IRON WORKERS LOCAL 399
New Welding Training Facility
Addendum #1
July 11, 2019

Bid Package Clarification and Changes

JOB IRONWORKERS LOCAL 399
TITLE PLUMBING SHEET NOTE REVISION
SHEET NO. SKP-2
DATE 7/10/2019 JOB NUMBER 5860
SCALE N.T.S.

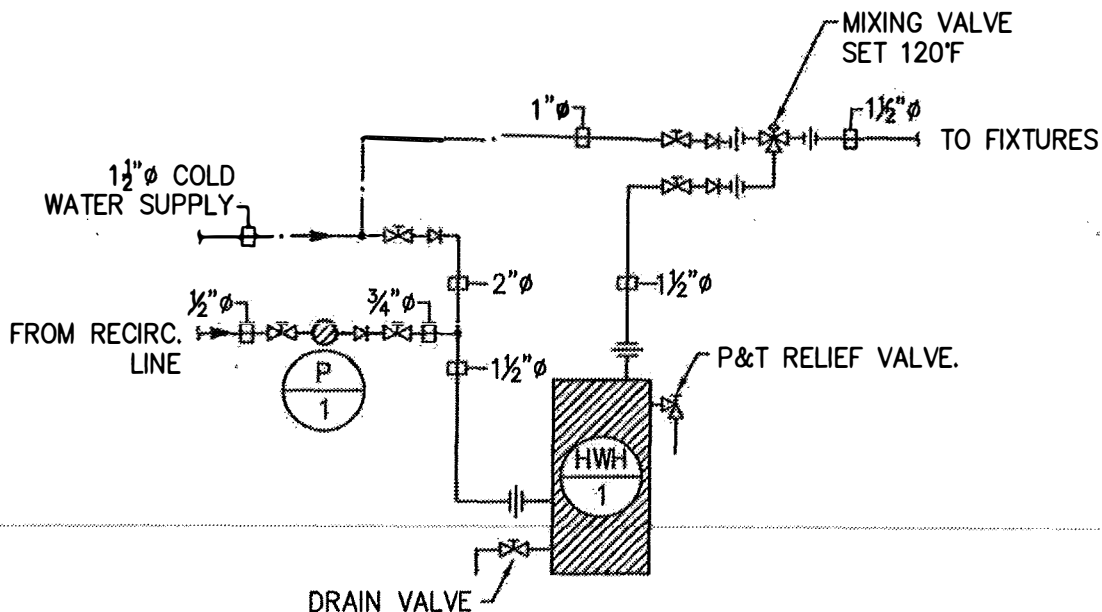
12. On Drawing P-1: Existing hot water heater located above existing bathroom to be removed, **see attached Sketch SKP-1.**
13. On Drawing P-3: Plumbing Note 7 revised, **see attached Sketch SKP-2.**

- 1 EXISTING TO BE REMOVED, ITEM AS INDICATED. REMOVE ALL SUPPORTS, APPURTENANCES, PIPE AND CONTROLS. REMOVE ALL PIPE TO POINT OF CONNECTION TO MAIN AND CAP MAIN OR TO BEHIND FINISHED SURFACES. PATCH AND RESTORE ALL EXISTING SURFACES TO MATCH EXISTING. VERIFY ALL CONDITIONS IN FIELD.

- 2 EXISTING TO REMAIN. PROTECT DURING CONSTRUCTION. VERIFY ALL EXISTING CONDITIONS IN FIELD, ITEM AS INDICATED.
- 3 EXISTING PLUMBING FIXTURE AND ALL PIPE AND APPURTENANCES TO BE REMOVED. VERIFY ALL CONDITIONS IN FIELD.

- 4 EXISTING SANITARY PIPE TO REMAIN.
- 5 REMOVE EXISTING DOMESTIC WATER PIPE.
- 6 EXISTING GAS PIPE TO REMAIN.
- 7 EXISTING GAS METER TO BE REMOVED AND REPLACED WITH NEW GAS METER PER GAS COMPANY REQUIREMENTS.

- 8 REMOVE EXISTING FLOOR SLAB AND CONNECT EXISTING SANITARY LINE TO NEW SANITARY LINE. VERIFY SIZE AND LOCATION IN FIELD.
- 9 CONNECT NEW DOMESTIC WATER TO EXISTING DOMESTIC WATER PIPE FROM WELL. VERIFY EXISTING PIPE AND REPAIR PIPE AND PROVIDE SHUTOFF VALVES.
